UNITED STATES PATENT AND TRADEMARK OFFICE

APPLICATION NO.	FILING DATE	FIRST NAMED INVENTOR	ATTORNEY DOCKET NO.	CONFIRMATION NO.
10/626,760	07/21/2003	Rajiv V. Joshi	909A.0128.U1(US)	1720
29683	7590	11/08/2004	EXAMINER	
HARRINGTON & SMITH, LLP 4 RESEARCH DRIVE SHELTON, CT 06484-6212			NGUYEN, THINH T	
			ART UNIT	PAPER NUMBER
			2818

Office Action Summary	Application No.	Applicant(s)	
	10/626,760	JOSHI ET AL.	
	Examiner	Art Unit	
	Thinh T. Nguyen	2818

DETAILED OFFICE ACTION

FIG. 4A

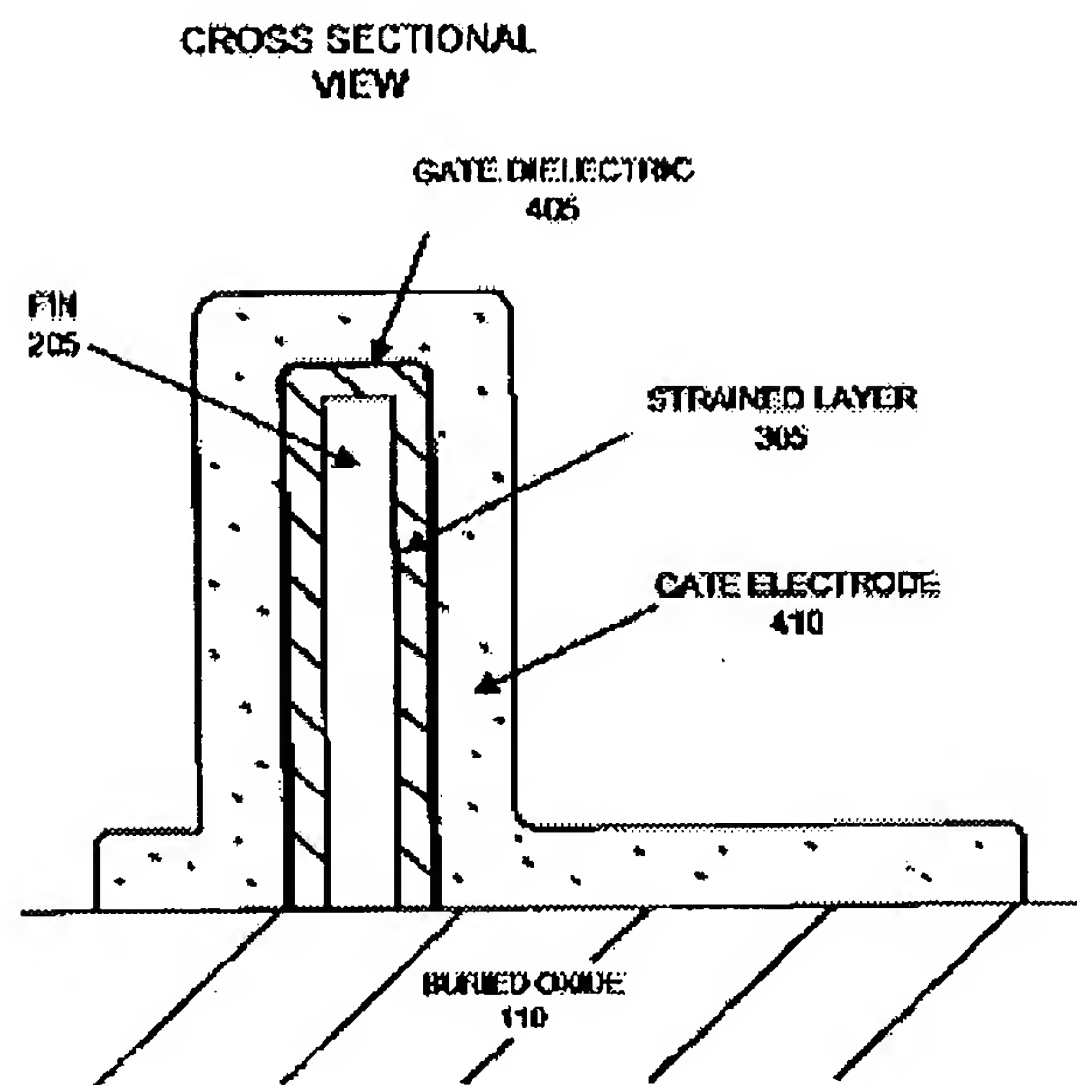
Similarly Dakshina-Murthy et al. (the abstract, fig 4A, column 3 lines 19-36) and Clark et al (fig 31, the abstract, column 3 line 45-56) disclose the same inventions.

Similarly Dakshina-Murthy et al. (the abstract, fig 4A, column 3 lines 19-36) and Clark et al (fig 31, the abstract, column 3 line 45-56) disclose the same inventions.
